Subject: Response to Review Comments
Preliminary Geotechnical Investigation
Proposed Pacific Center Development
1071 N. Tustin Ave., 1065 Pacific Center Dr., and 1041 W. Pacific Center Dr.,
Anaheim, California

1. Anaheim 2017. *Geotechnical Engineering Review Sheet, City of Anaheim, Plan Check #OTH 2017-00946*, Albus-Keefe & Associates, AKA Project Number 2608.0, April 26, 2017.
2. NOVA 2017. *Report, Preliminary Geotechnical Investigation, Proposed Pacific Center Development, Anaheim, California*, NOVA Services, Inc., February 17, 2017.

Project: NOVA Services, Inc.

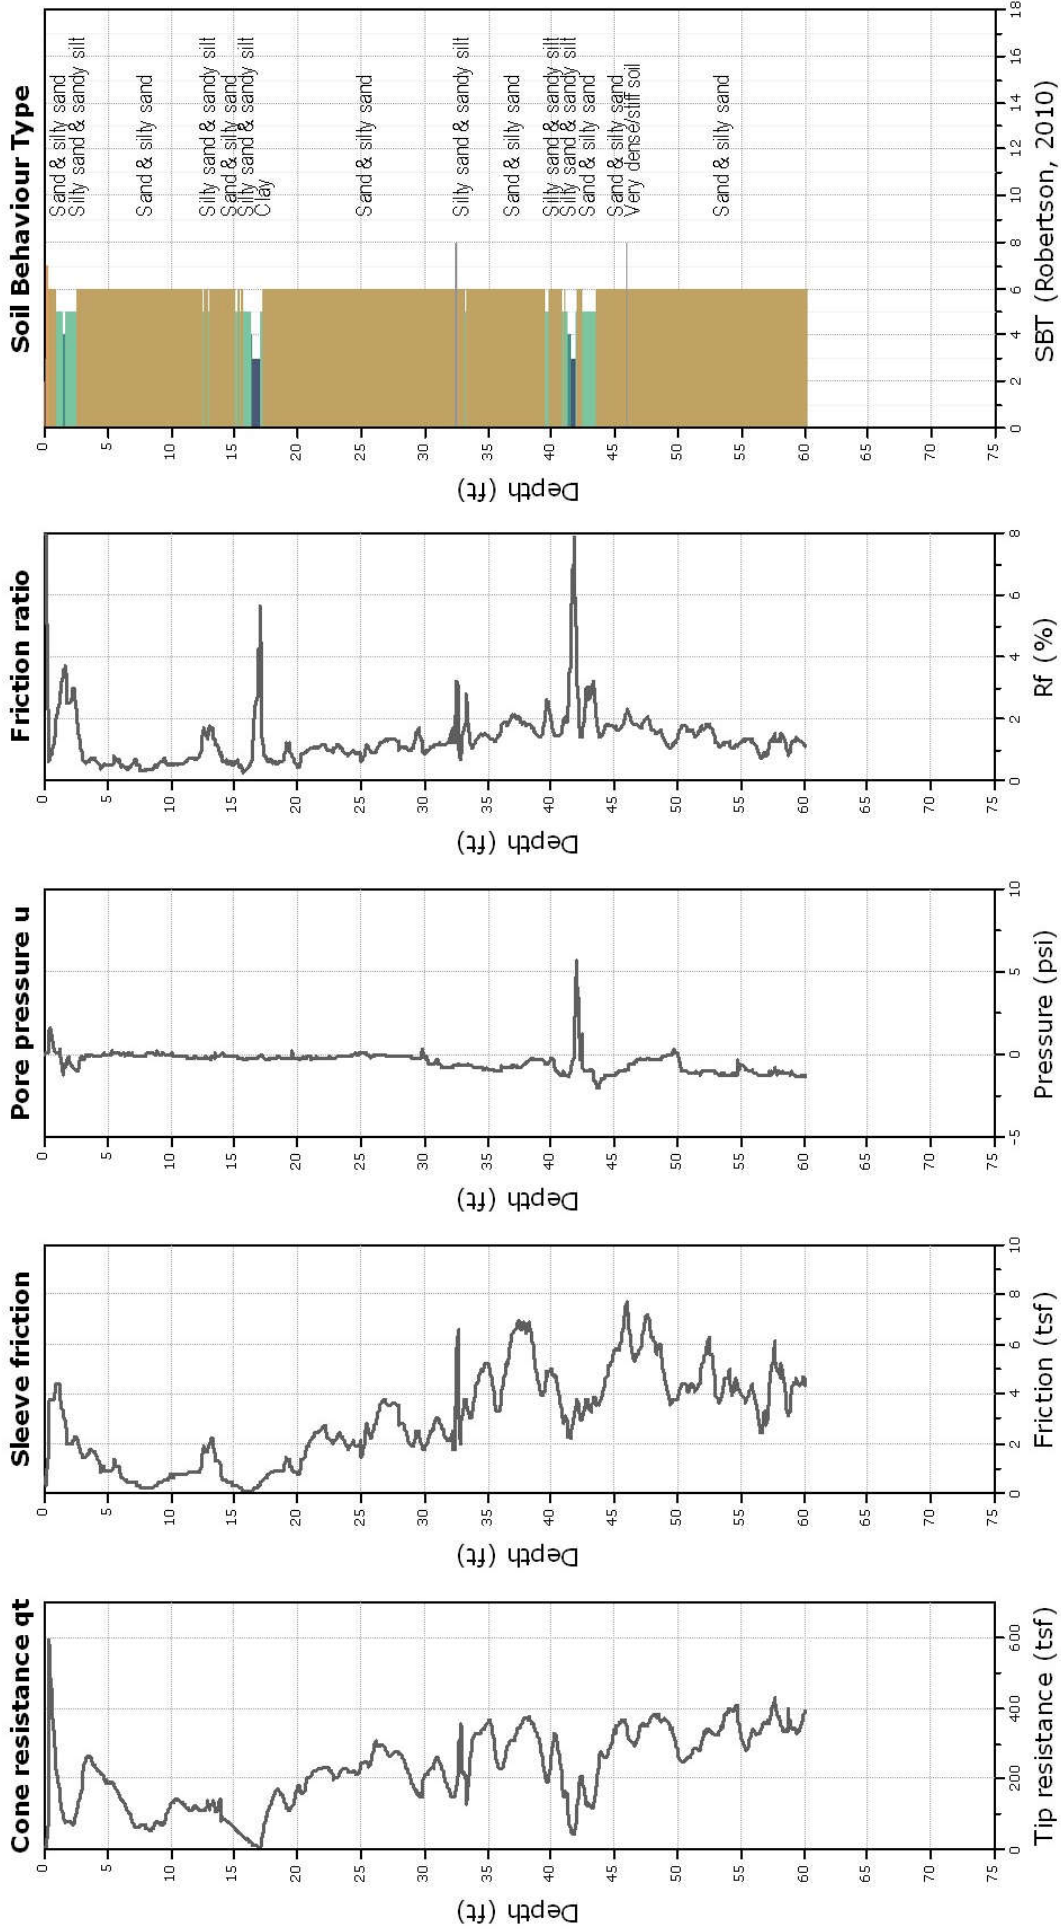
Comment 1, CPT Data. *Section 1.4 (and a few other sections) state that Cone Penetration Test (CPT) data were provided in Appendix C. We could not find CPT data in this or other appendices. Please provide CPT data.*

Response 1. Attachment 1 to this letter provides *Summary of Cone Penetration Test Data* by Kehoe Testing and Engineering, dated January 14, 2017.

Liquefaction analysis overall plots

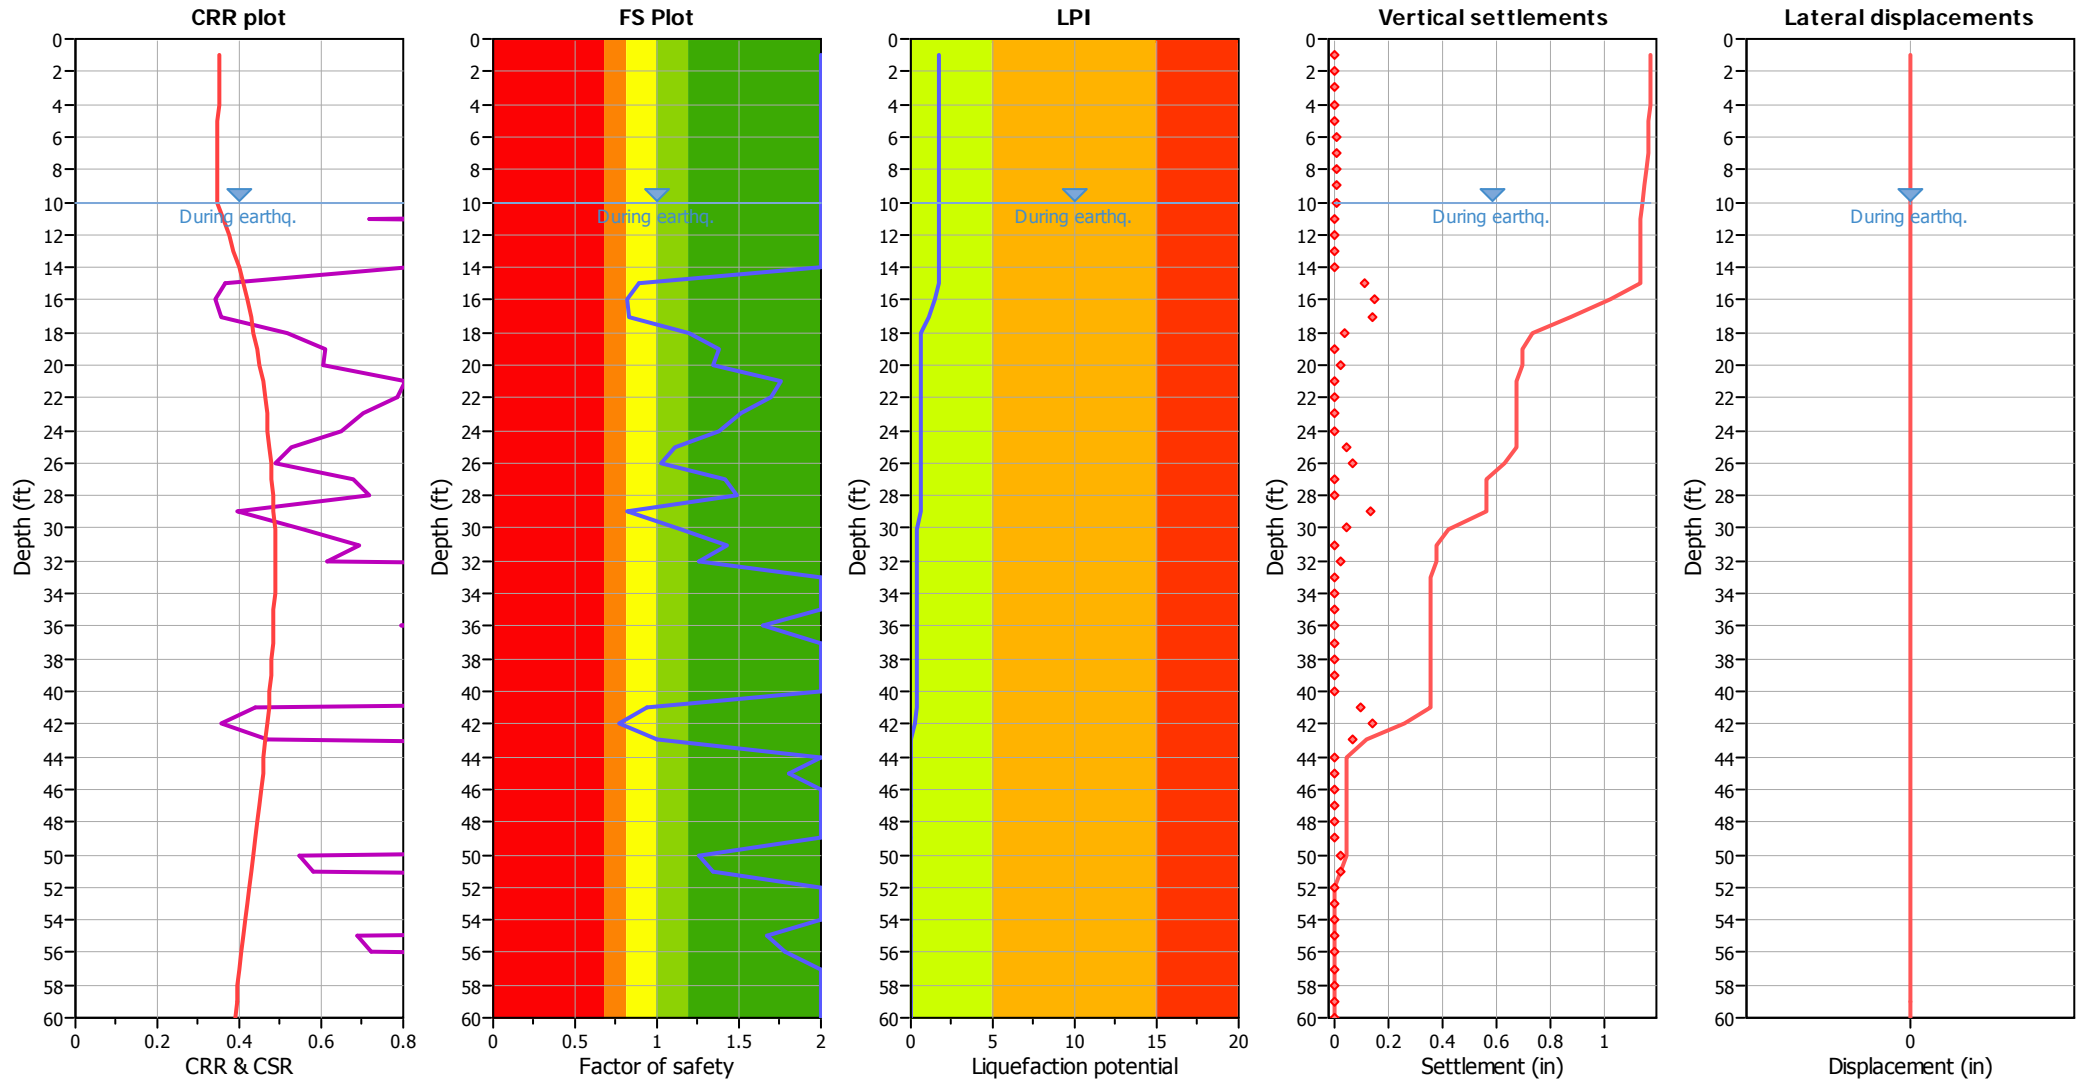
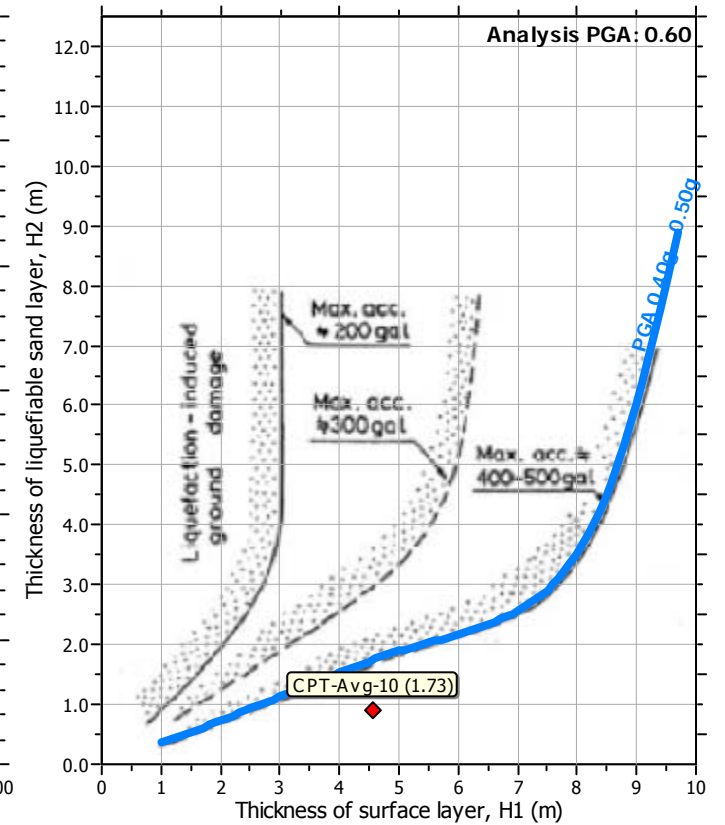
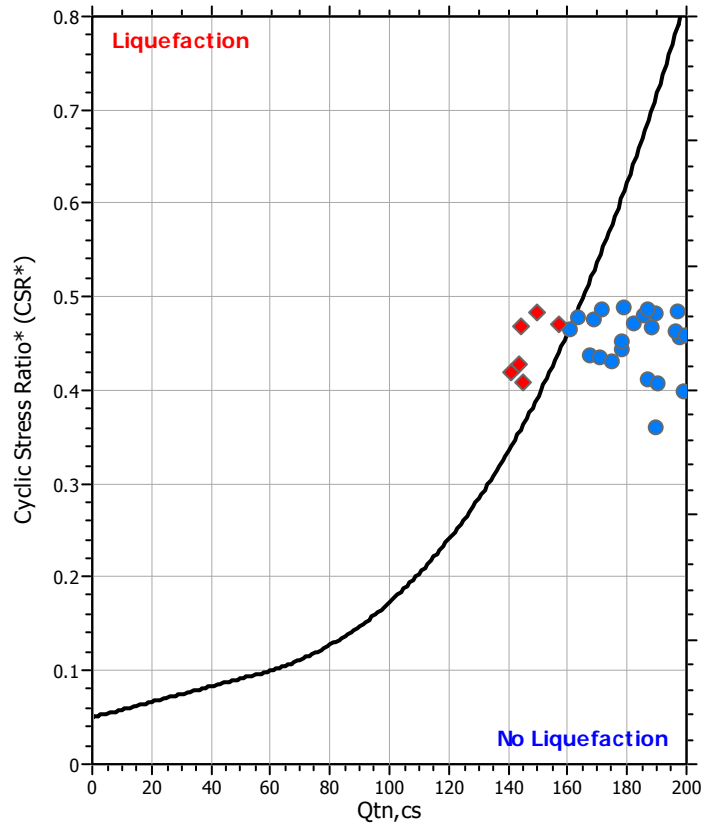
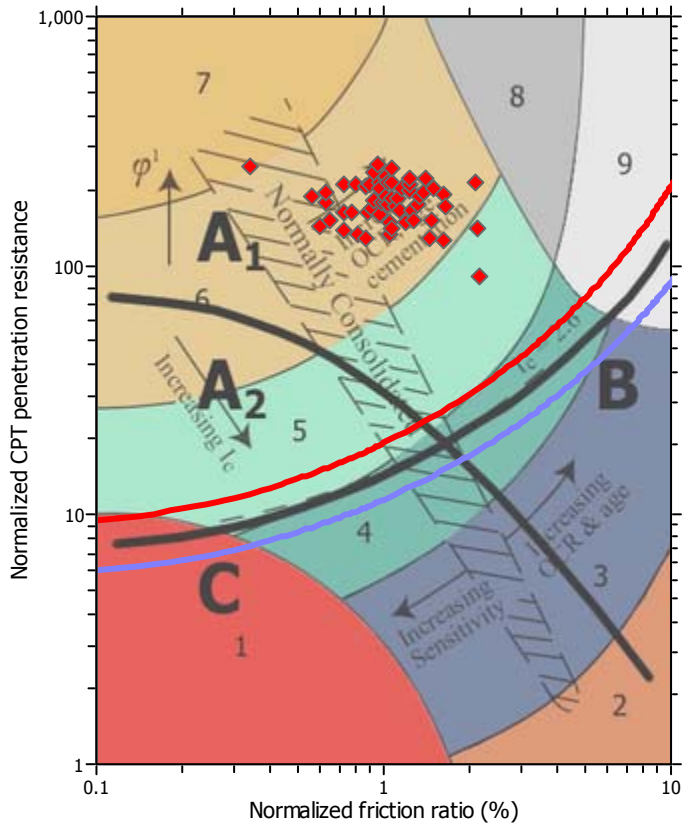
Comment 4, Factor Safety against Liquefaction. *Figure 5-1 suggests that factor of safety $FS=1.0$ is used for evaluation of liquefaction potential. However, California Special Publication 117A (Guidelines for Evaluating and Mitigating Seismic Hazards in California; California Geological Survey, 2008) requires a factor of safety greater than or equal to 1.3. Please comment or revise liquefaction analysis accordingly.*

Comment 5, Lateral Spreading. *In Section 5.3.4, potential for lateral spread is reported to be non-existent. This evaluation is based on the gentle ground slope in the vicinity of the site, among other things. However, lateral spread due to slope face (free face) nearby has not been discussed. Both Santa Ana River and Warner Basin may provide a slope face, facilitating lateral spread. Please comment.*

Response 4. The CDMG guidelines in Special Publication 117A do not require a specific factor safety. As noted above, NOVA has reconsidered the liquefaction analyses utilizing a groundwater level at 10 feet bgs.

As may be seen by review the data provided in Attachment 2, analyses using the Robertson 2001 method indicate an overall low probability of liquefaction. Moreover, zones of soils at risk from liquefaction are relatively deeper. NOVA's assessment of the risk of damage to structures is that this deeper-seated potential movement beneath densely compacted surface sands will be associated with lower potential for differential foundation movement that could be damaging to structures.

Response 5. As may be seen by review of the liquefaction analyses provided as Attachment 2, no lateral spreading is forecast for the approximately level site.

Direct Shear Data

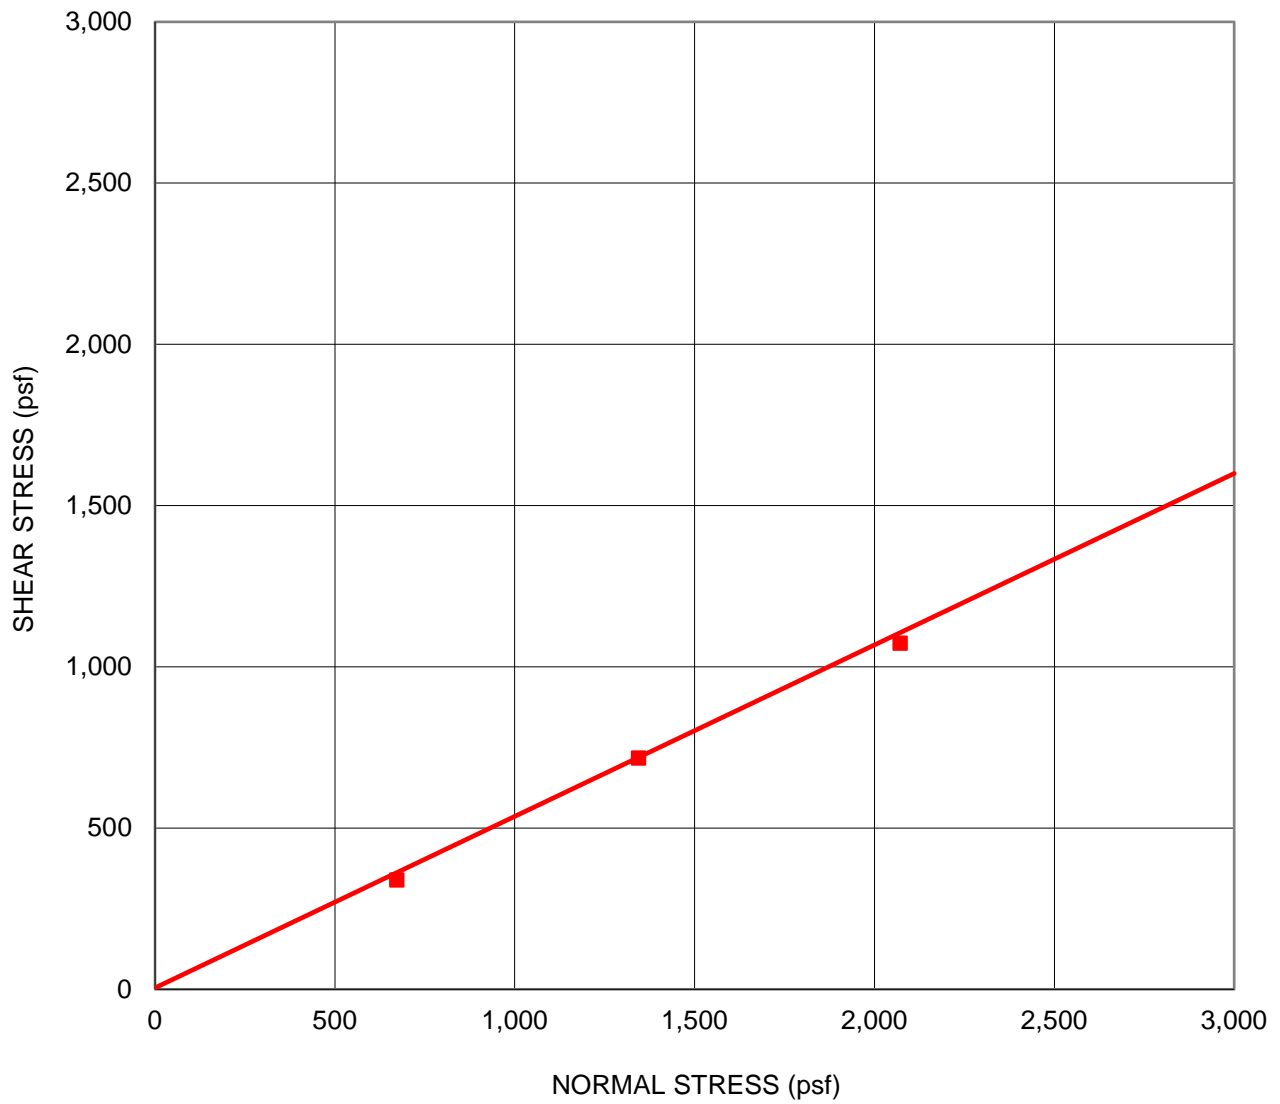
Comment 7, Direct Shear Data. *Direct shear test results are discussed in Section 3.5.2 (item #1 in this section provides friction angle and cohesion). However, results for this test were not found in Appendix B. Please provide. Furthermore, it is not discussed if this test was performed on a remolded specimen or on an undisturbed sample?*

Response 7. The direct shear data is provided as Attachment 3 to this letter.

The direct shear testing was conducted on an undisturbed sample of the Unit 2 sands obtained by the Modified California Sampler ASTM D3550. Near the ground surface these sands are of loose consistency, intended to be improved by the earthwork described in Section 6 of NOVA 2017.
